Notice of Intent

Sundry ID: 2754851

Type of Action: APD Change

Procedure Description: Mewbourne Oil Company request a variance to perform break testing and offline cementing on the following wells: Querecho 23/26 Fed Com 523H Querecho 23/26 Fed Com 616H Night Watch 2/1 Fed Com 511H Night Watch 2/1 Fed Com 513H Gemini 36/35 Fed Com 513H Gemini 36/35 Fed Com 516H Corona 25/26 Fed Com 525H Corona 25/26 Fed Com 528H Pavo Macho 31/33 Fed Com 616H Pavo Macho 31/33 Fed Com 618H

Figure 5. Cactus 5M wellhead with BOP quick connect

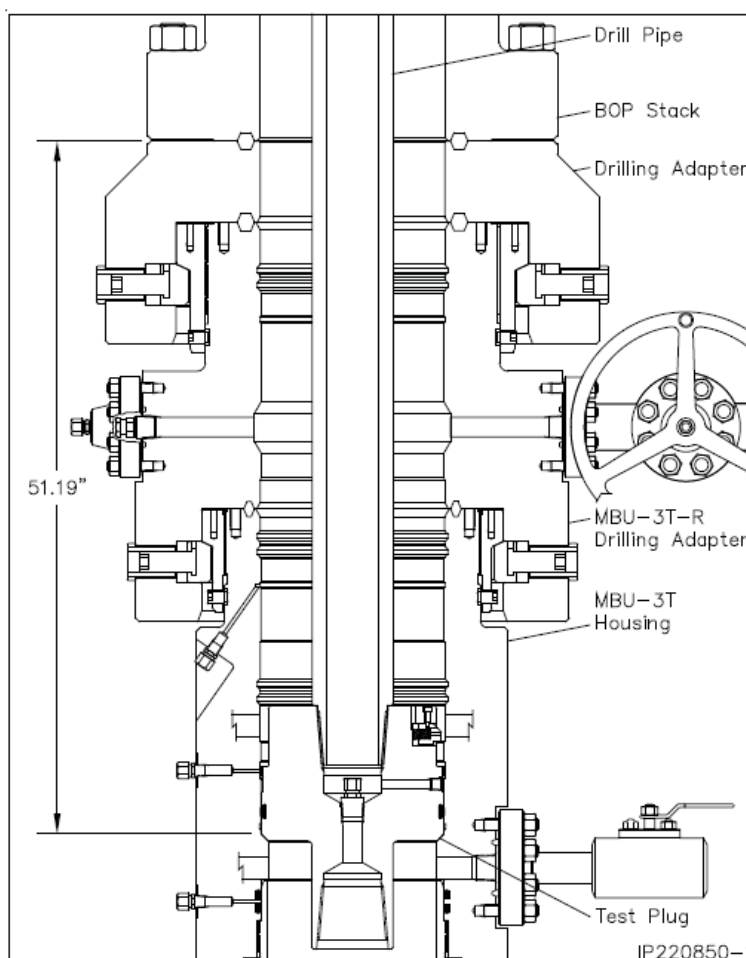
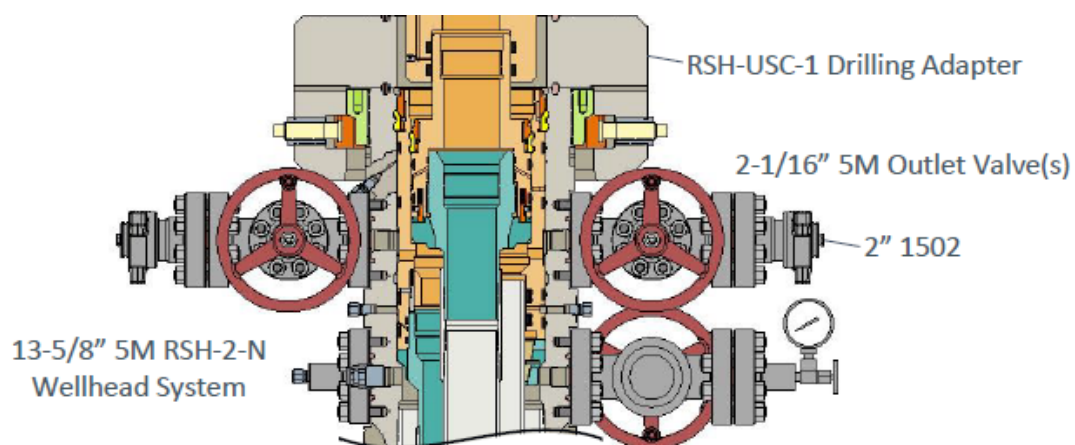
- Connection between the flex line and the HCR valve
 - Connection between the wellhead and the BOP quick connect (Fig. 5 & 6).
3. A capping flange will be installed after cementing per wellhead vendor procedure & casing pressure will be monitored via wellhead valve.
